UNITED STATES PATENT AND TRADEMARK OFFICE

APPLICATION NO.	FILING DATE	FIRST NAMED INVENTOR	ATTORNEY DOCKET NO.	CONFIRMATION NO.
10/759,702	01/17/2004	Steve Lewison	SCL002	8457
7590	07/18/2006		EXAMINER	
Steve Lewison 14269 Aspen Avenue Prior Lake, MN 55372			GILBERT, WILLIAM V	
			ART UNIT	PAPER NUMBER
			3635

Office Action Summary

DETAILED ACTION

Figure 1 from Swan et al.

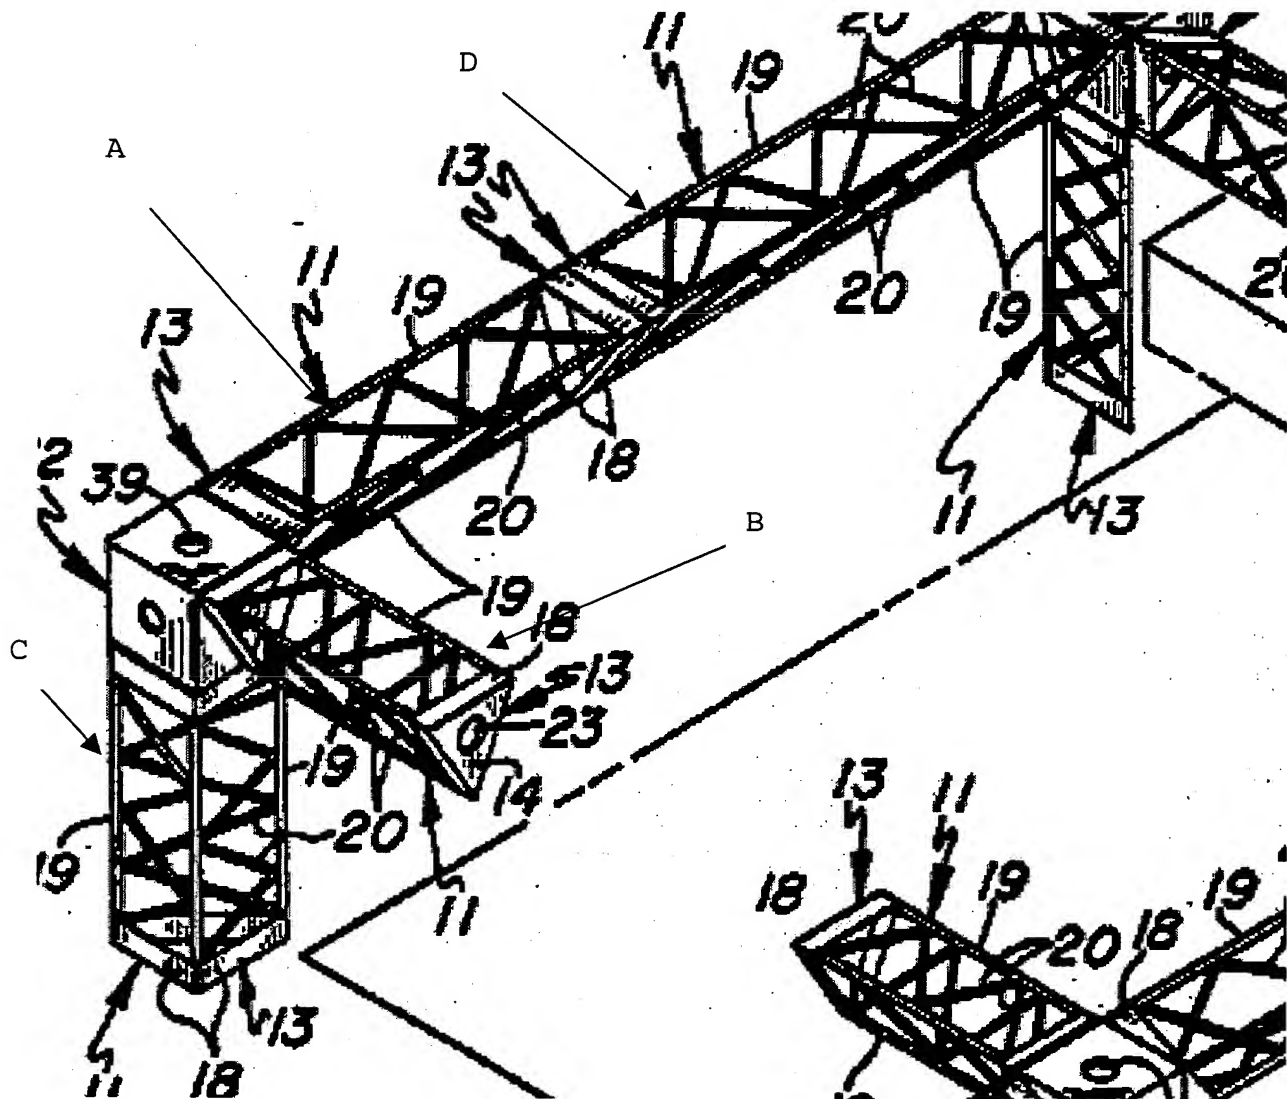
Regarding Claims 11-14, Fisher discloses the claimed invention excepted that for a hub where the at least two truss spans radially extend from the hub (per Claim 11), where a first one of the truss spans extends in a generally vertical direction from the hub and a second truss extends in a general horizontal direction from the hub (per Claim 12), where a third truss is

connected in a generally horizontal direction from the hub (per Claim 13) and where a first truss span is connected in-line to a second truss span (per Claim 14). Swan discloses a truss system (See Figure 1, generally), with a hub (12) where at least two truss spans radially extend from the hub (per Claim 11, see Elements A and B from attached Figure 1 of Swan, below), where a first one of the truss spans extends in a generally vertical direction from the hub and a second truss extends in a general horizontal direction from the hub (per Claim 12, see Elements C and B respectively from attached Figure 1 of Swan, below), where a third truss is connected in a generally horizontal direction from the hub (per Claim 13, see Element B from attached Figure 1 of Swan, below) and where a first truss span is connected in-line to a second truss span (per Claim 14, see Elements A and D from attached Figure 1 of Swan, below). It would have been obvious at the time the invention was made to a person having ordinary skill in the art to form the truss system in Swan from the truss as disclosed in Fisher. One would have been motivated to make such a modification because the disclosure in Fisher notes that it is well known in the art to use truss systems for "exhibition, display and concert staging" (see Column 1, lines 26-36), and the disclosure in Swan discloses that its truss system is typical for the entertainment industry (see Column 1,

lines 10-12). The Truss in Fisher has the capability of being used as disclosed in Swan, and the various configurations of the truss members are well known in truss assembly.

Figure 14 from DeMeyer

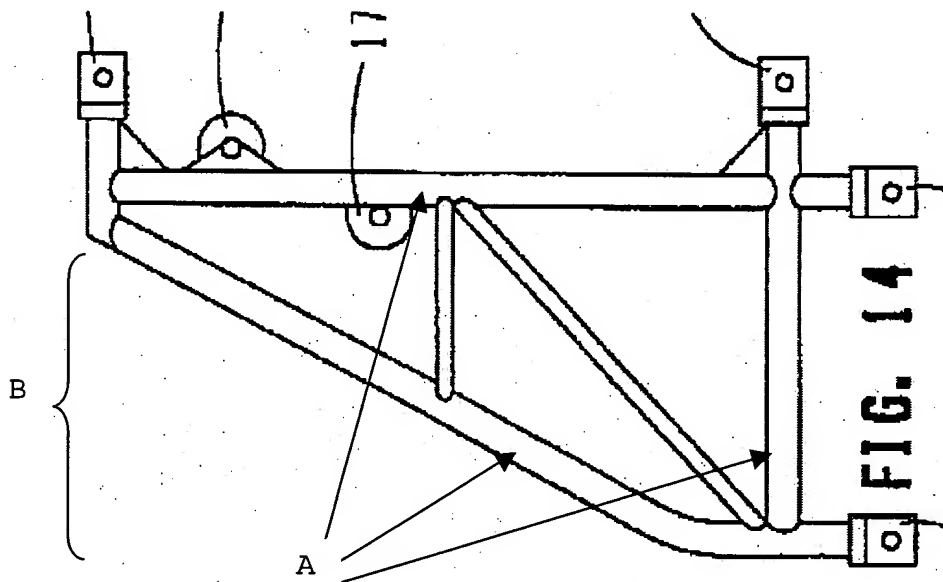
Regarding Claim 20, Fisher discloses the claimed invention except for the plurality of connection members, each connection member including a plurality of members, and each connection member including a tapered end. DeMeyer discloses a truss (Figures 15 and 16) further comprising a connection member (Figures 12, 14) each connection member including a plurality of members (see elements "A" from attached Figure 14 from DeMeyer below), and the connection member (Figure 14, generally) having a tapered end (see element "B" from attached Figure 14 from DeMeyer below). It would have been obvious at the time the invention was made to a person having ordinary skill in the art to use the connection member in DeMeyer with the truss in Fisher. One would have been motivated to make such a modification because the connection member in DeMeyer permits connections to other truss members at angles less than 90 degrees and therefore offers greater versatility. Additionally, while Claim 20 claims a plurality of connection members, it would be obvious that a plurality of connection members would be required to connect each truss to a hub. The phrase "adapted to connect to the hub such that a number of connection members are

able to be attached to a single hub to radially extend from the hub in a single plane," is a statement of intended use of the claimed invention and must result in a structural difference between the claimed invention and the prior art in order to patentably distinguish the claimed invention from the prior art. If the prior art structure is capable of performing the intended use, then it meets the claim. Here, it is clear the connection member is capable of being attached to a single hub.
